# Access Compliance Report

## Public Rights-of-Way

### (Curb Ramps)

Intersection ID: N/A	Main Street: MATTHEWS_FARM_LN	Cross Street: N/A	Location: SE
ADA ID: F6016ABA813E	Ramp Type: Perp	Initial Pass/Fail: Fail	Overall Compliance: No
Codes/Mitigation Info/Possible Solution		Field Measurements/Component Compliance	
Severity Score: 13.75

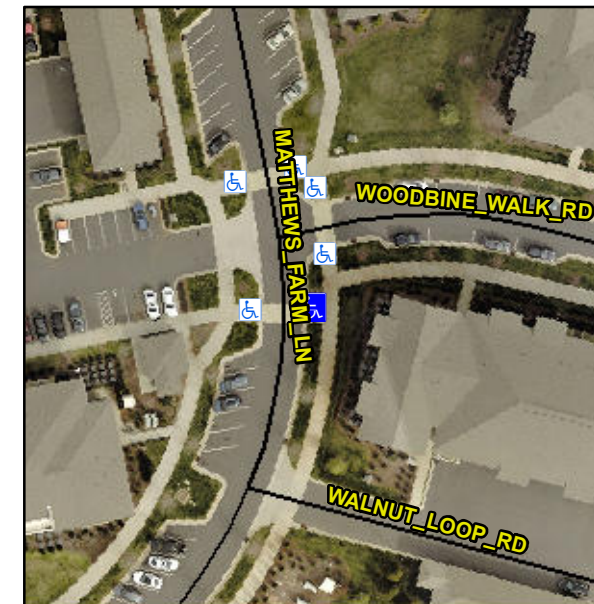
**Not Found, R304.2.2, R304.5.3**

Compliance	Description	Data	Compliance	Description	Data
N/A	Ramp Length (in)	94.0	No	Ramp Slope (%)	9.4
Yes	Ramp Width (in)	99.0	No	Ramp XSlope (%)	3.8
N/A	Flare Type LT	N/A	N/A	Flare Type RT	N/A
N/A	Flare Slope LT (%)	N/A	N/A	Flare Slope RT (%)	N/A
N/A	Flare Traversable LT?	N/A	N/A	Flare Traversable RT?	N/A
N/A	Landing Length (in)	N/A	N/A	DWS Provided?	N/A
N/A	Landing Width (in)	N/A	N/A	DWS Contrast?	N/A
N/A	Landing Slope (%)	N/A	N/A	DWS Length (in)	N/A
N/A	Landing X Slope (%)	N/A	N/A	DWS Full Width?	N/A
N/A	Landing Curb? (Y/N)	N/A	N/A	DWS Offset (in)	N/A
N/A	Shared Landing?	N/A			
N/A	Gutter Ponding?	N/A	N/A	Gutter Slope (%)	N/A
N/A	Gutter Lip Ht (in)	N/A	N/A	Gutter X Slope (%)	N/A
N/A	Painted X Walk1?	No	N/A	Painted X Walk2?	N/A
	X Walk 1 Direction	To W		X Walk 2 Direction	N/A
N/A	X Walk 1 Width (in)	N/A	N/A	X Walk 2 Width (in)	N/A
	X Walk 1 Slope (%)	2.2		X Walk 2 Slope (%)	N/A
	X Walk 1 X Slope (%)	2.4		X Walk 2 X Slope (%)	N/A

**Remove & Replace Entire Ramp.**
